AK Planning

29 January 2025

RE: SUBMISSION ON DA2024/1708 - 2A ALLEN AVENUE BILGOLA BEACH

Figure 1: Section AA excerpt with building height variation shaded in red

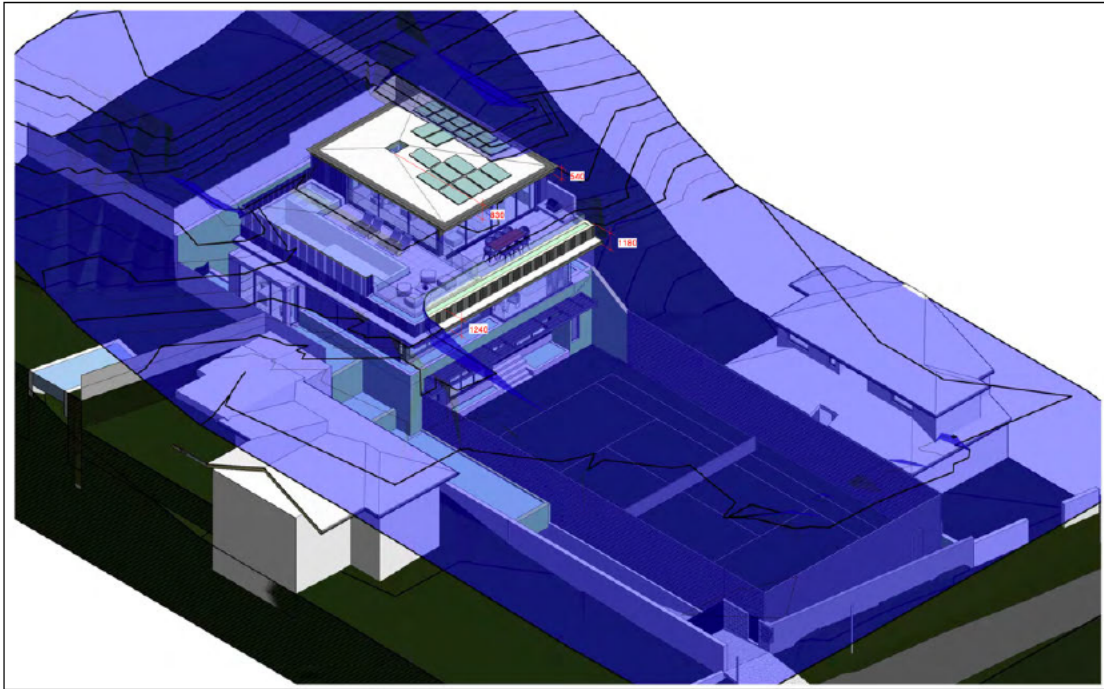
The building height as measured from the existing ground level to the maximum ridge height of RL18.30, is 9.24m, resulting in a maximum 1.24m exceedance of the 8m building height control pursuant to Clause 4.3 of the Pittwater LEP 2014 – refer to **Figure 1**.

The Clause 4.6 lodged with the development application relies on undisturbed ground level prior to any development on the site to measure building height. The applicant Cl4.6 is understating the degree of non-compliance with the building height because of the interpretation of the definition of building height.

I do not agree with the applicants approach. The measurement of height is to be consistent with the definition within the PLEP and taken from the ground level that is ‘**existing**’. That word cannot be ignored. The existing ground level is readily discernible on site and can be relied upon to determine levels.

Figure 2: Rear setback non-compliance shaded in red

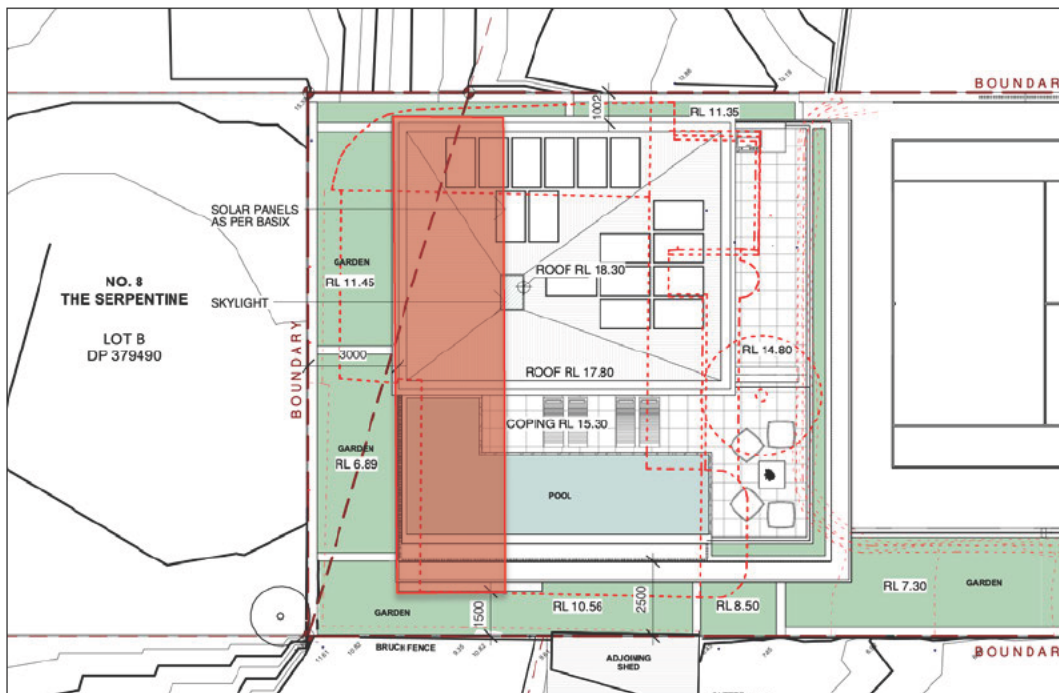
D3.7 of Pittwater21 DCP requires a side setback of 1m to one side, and 2.5m to the other as well as a minimum rear setback of 6.5m. The proposal allows for a minimum side setback of 1.5m for Levels 1 & 2 along the southern boundary and a rear setback of 3m resulting in a non-compliance with the control – refer to **Figure 2** below.

The desire to retain the tennis court and to obtain water views, necessitate the siting of the dwelling towards the rear of the site. Consequently, the proposal seeks to locate the multi-level dwelling within the remaining relatively small developable area, with a third of the new footprint located within the rear setback area. The rear setback of the dwelling is inconsistent with the siting of adjoining properties.

Figure 3: Non-compliance with building envelope
Source: Applicants Architectural plans

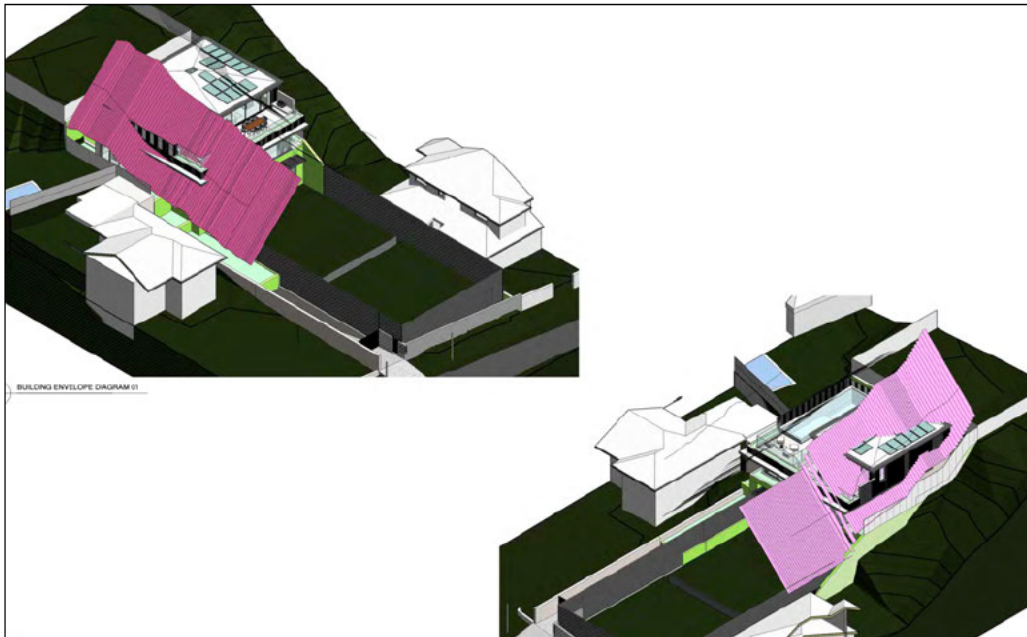
D3.9 of the Pittwater21 DCP requires building planes to be projected at 45 degrees from a height of 3.5m above existing ground level at the side boundaries to the maximum building height. The “amended” development application results in a non-compliance along the northern and southern elevations – refer to **Figure 3**.

The non-compliance with the building envelope results in a massing which becomes visually dominating by virtue of its height and bulk and impacts directly on views. The proposal by virtue of the non-compliance does not respond to the site topography or that of surrounding land. Locating the dwelling further up the hill results in a massing which dominates the surrounding.

Figure 4: Overlooking opportunity

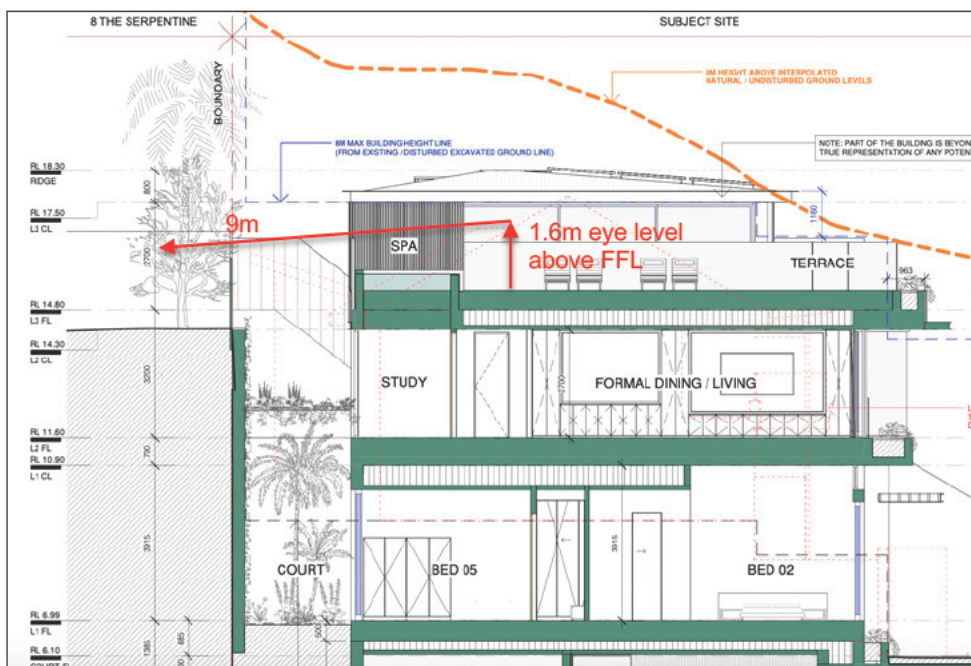
The elevated pool is located 3m from the rear boundary with a finished coping level at RL15.8 and the pool terrace level at RL15.3. The top of the proposed screen is at RL16.6 being only 1.3m above the proposed FFL of the terrace. **Figure 4** below demonstrates the opportunity for direct overlooking from the pool terrace at an eye level of 1.6m for a length of 9m into the backyard of No. 8 The Serpentine.

The proximity of the pool to the rear and side boundaries as well as the elevated nature of this active recreational use results in an adverse impact on visual and acoustic privacy. Moreover, there are no elevated pools within the immediate area, accordingly the pool and spa are inconsistent with the surrounding neighbourhood character. Allowing an elevated pool will set an undesirable precedent within the Bilgola Beach locality.
